**DOCUMENT 00 91 02  
ADDENDUM NO. 2**

PROJECT: 2024 Anthony, Hopper and Kahla MS Renovations

FROM: Carolina Weitzman, A.I.A.  
Natex Corporation Architects  
447 Heights Blvd, Houston, TX 77007

**1 ELECTRICAL LIGHTING 1ST FLOOR - AREA C**  
 Scale: 1/8" = 1'-0"

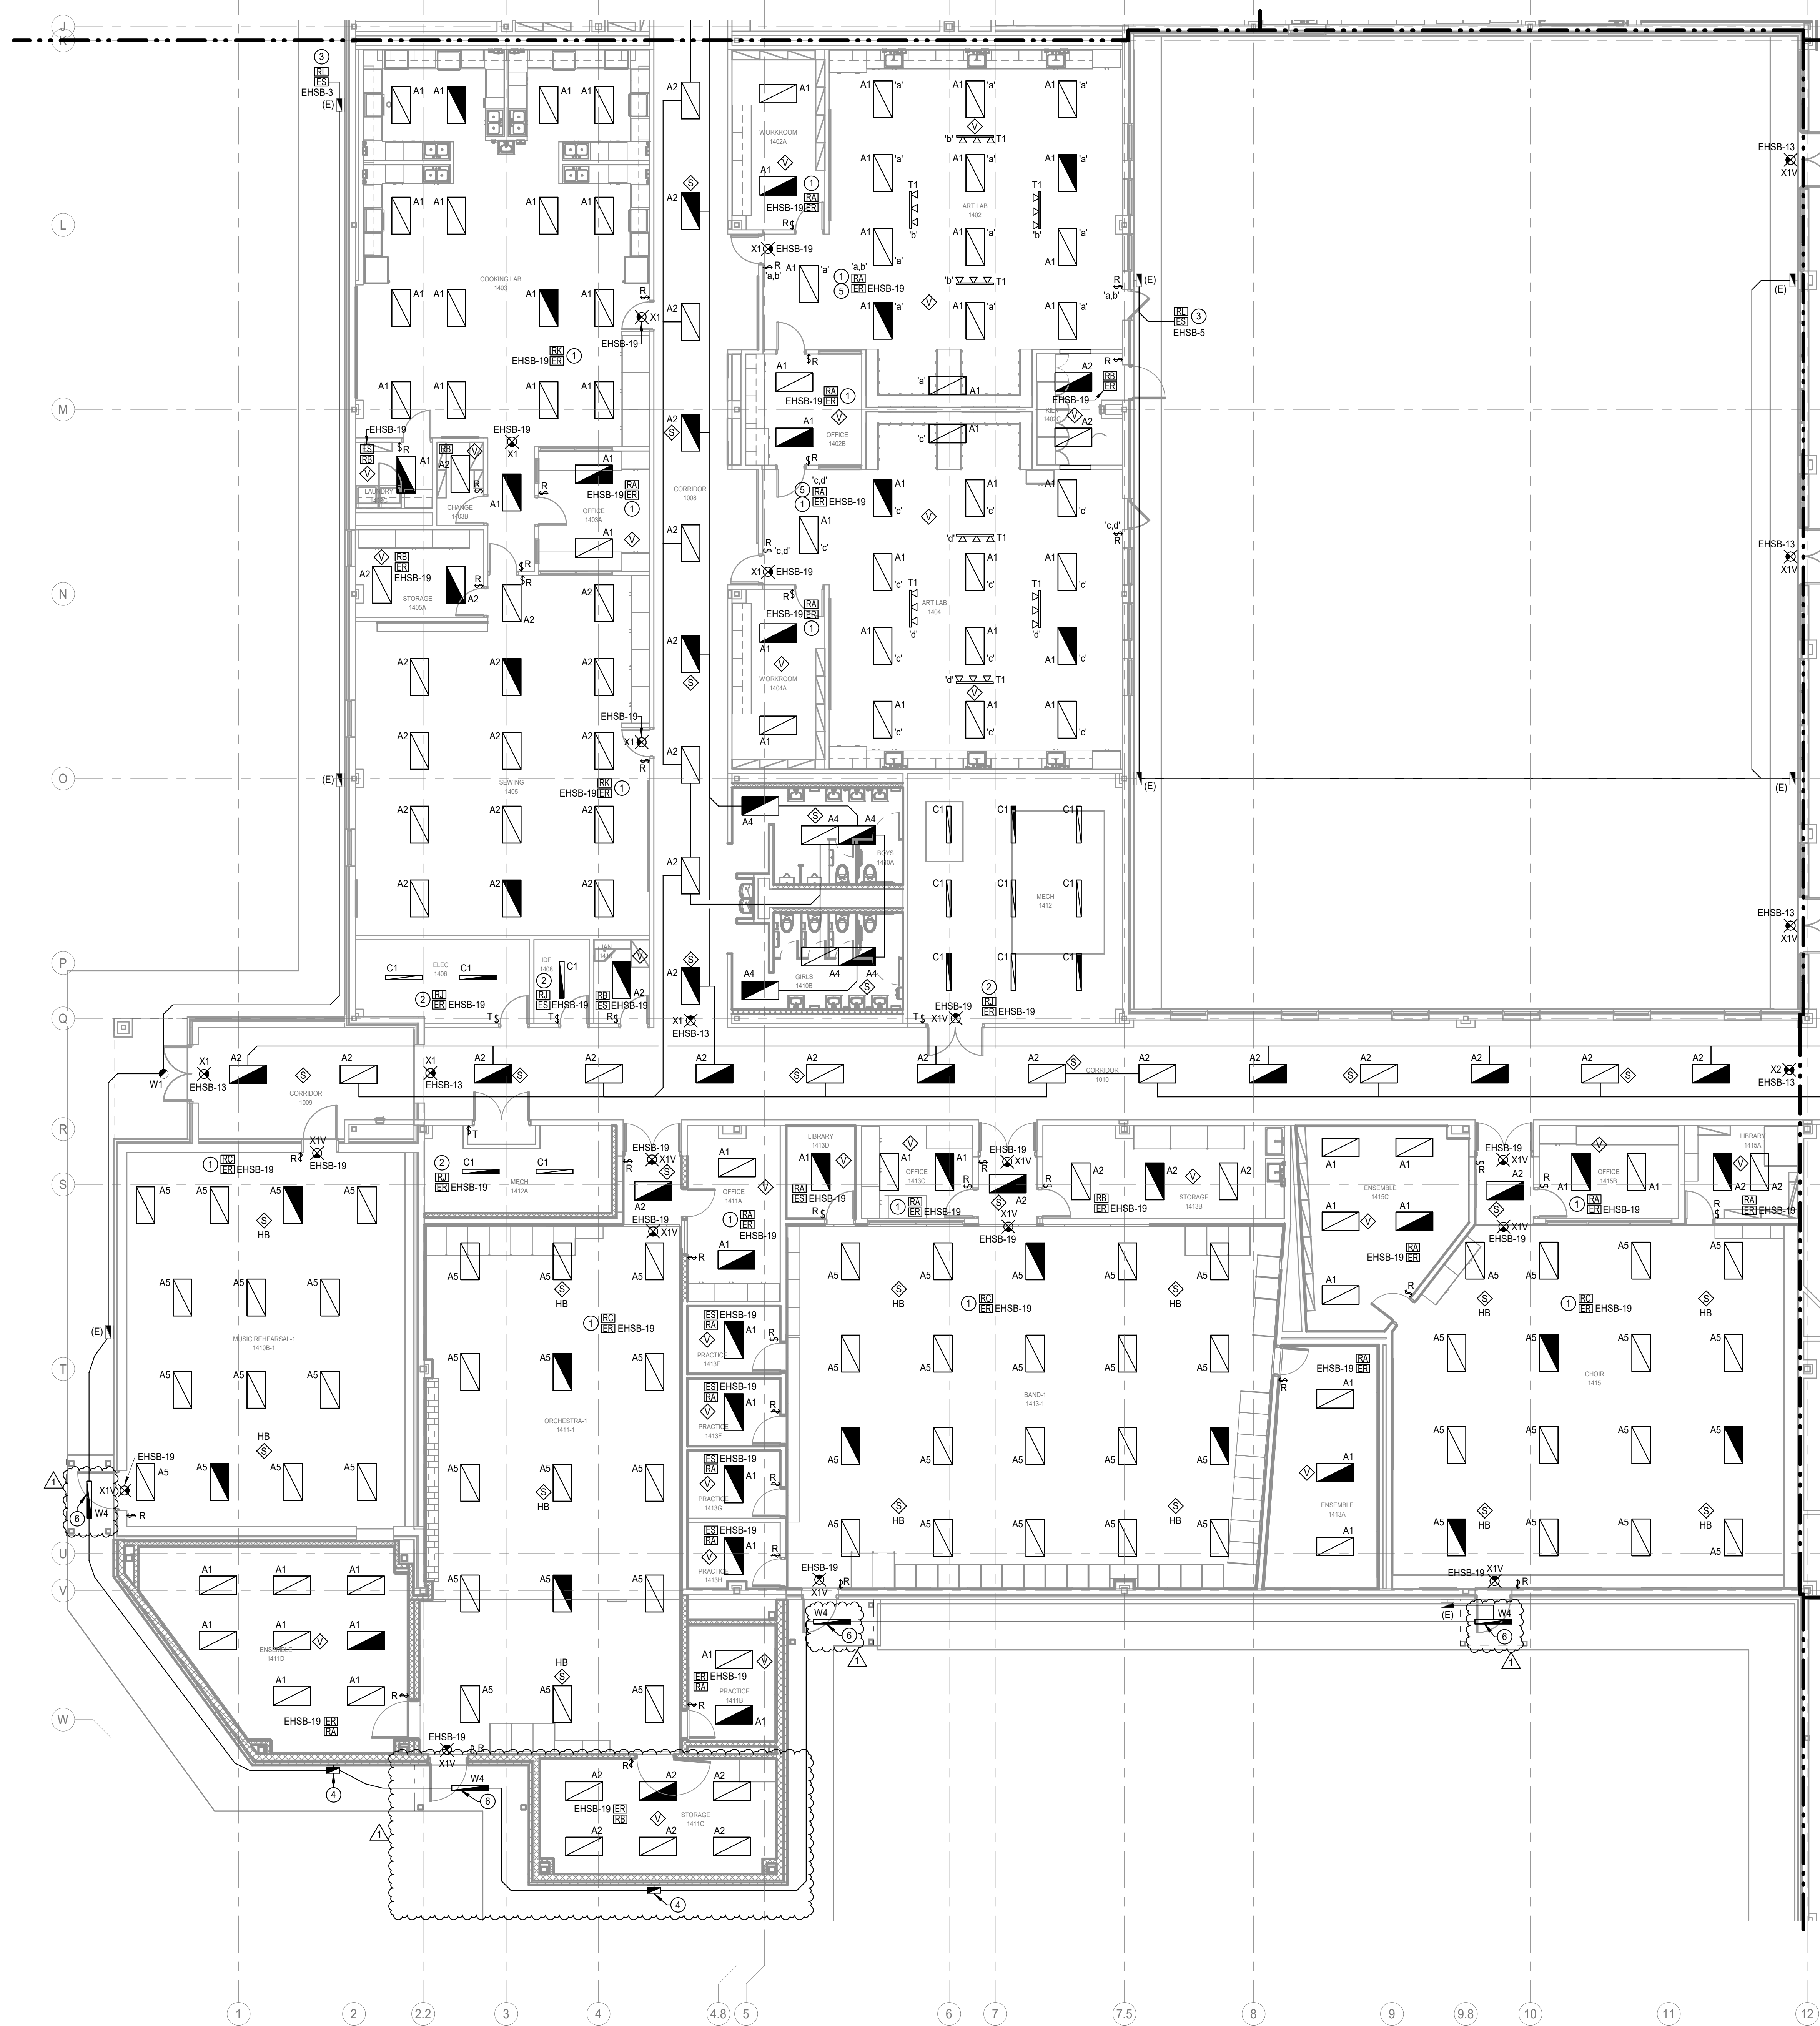
- a. Added air device replacement scope in restrooms.
41. M5.01 - MECHANICAL SCHEDULES
  - a. Updated DC-1 schedule.
42. SHEET E2.03 ELECTRICAL LIGHTING 1ST FLOOR - AREA 'C'

- a. Refer to revised sheet for new egress fixture.
43. SHEET E2.04 ELECTRICAL LIGHTING 1ST FLOOR - AREA 'D'
  - a. Refer to revised sheet for new egress fixture.

Project Number: 23072  
 Date: 29 DECEMBER 2024  
 Drawn by: NY  
**TECHNOLOGY COMPOSITE FIRST FLOOR PLAN**  
**T1.00**

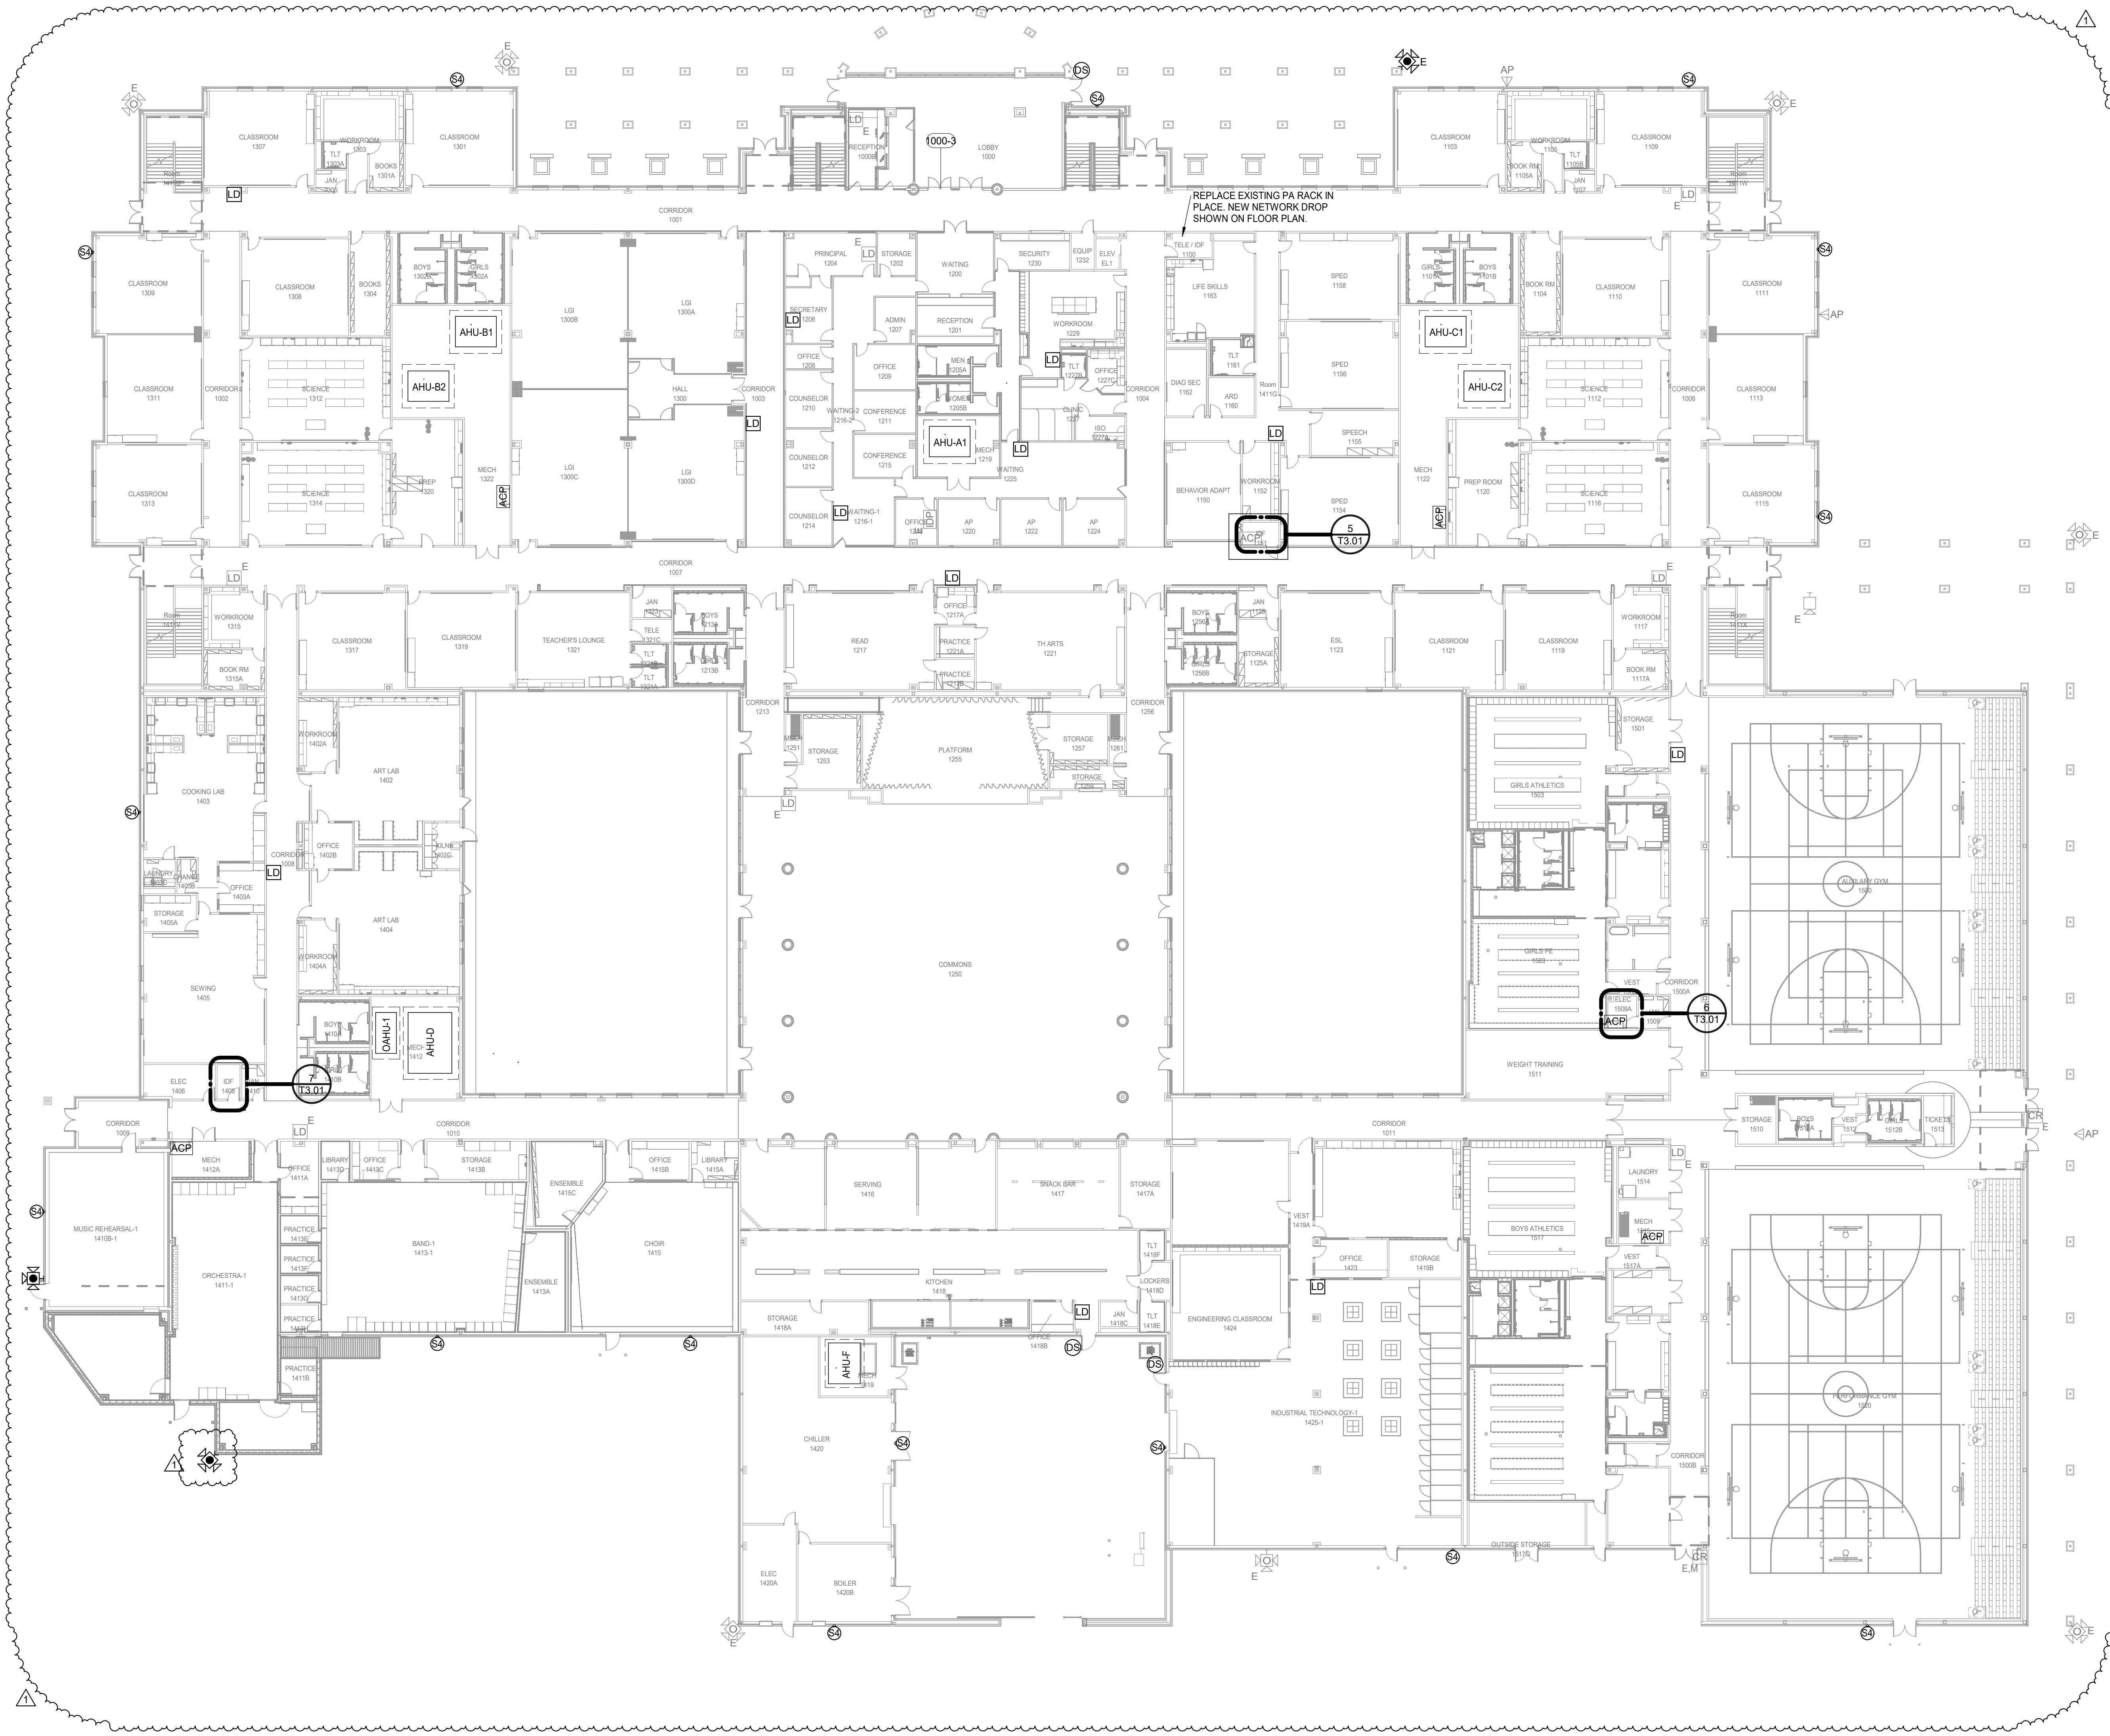
- b. Add Demo data drops in WORKRM 2119, classroom 2126 and 2121, PREP 2122 and science 2116.
61. T1.00 - TECHNOLOGY COMPOSITE FIRST FLOOR PLAN
- a. Remove sleeves from plan.

- b. Add camera outside of storage 1411C.
62. T1.01 - TECHNOLOGY COMPOSITE SECOND FLOOR PLAN
- a. Remove sleeves from plan.
63. T1.04 - TECHNOLOGY SITE PLAN – NEW

1. ADDENDUM #2	01/16/25	Revisions / Submission
Project Number:	23072	
Date:	29 DECEMBER 2024	
Drawn by:	NY	
<b>TECHNOLOGY FIRST FLOOR PLAN - AREA 'F'</b>		
<b>T2.06</b>

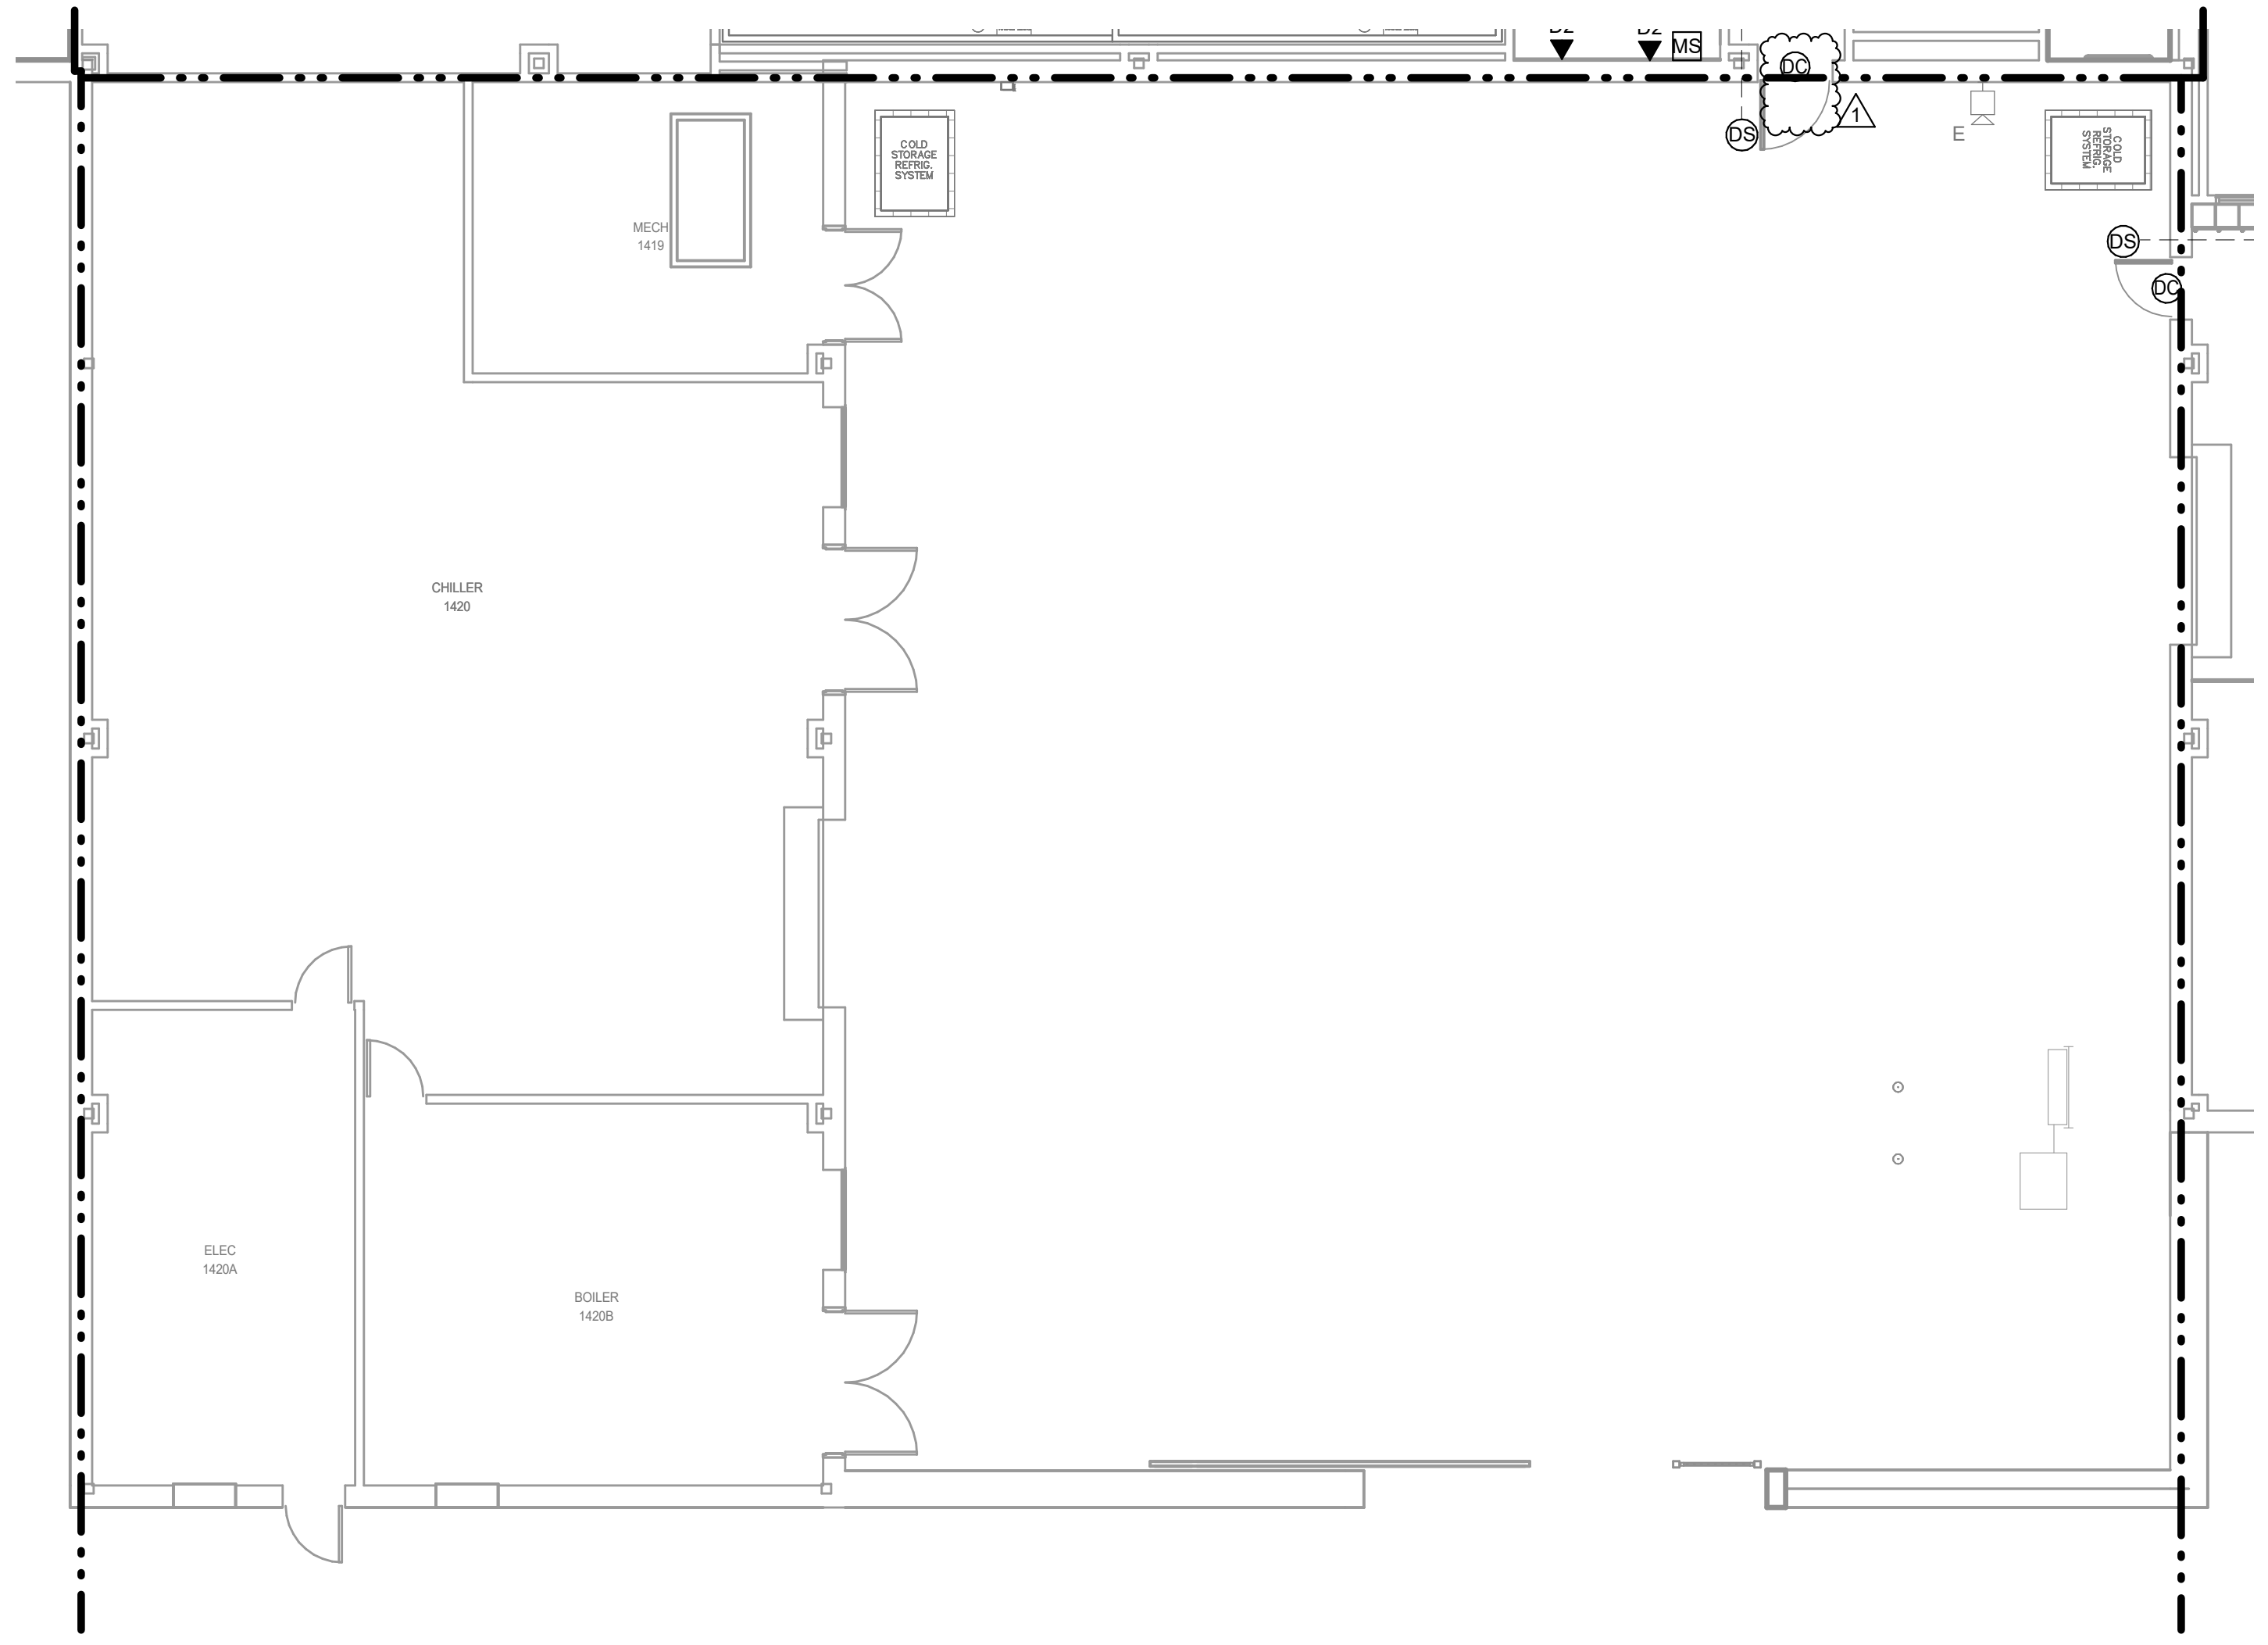
67. T2.06 - TECHNOLOGY 1ST FLOOR PLAN - AREA F
- a. Add door contact for 1418-1 door in kitchen 1418.
68. T2.07 - TECHNOLOGY FIRST FLOOR PLAN - AREA G
- a. Add technology plan keyed notes.
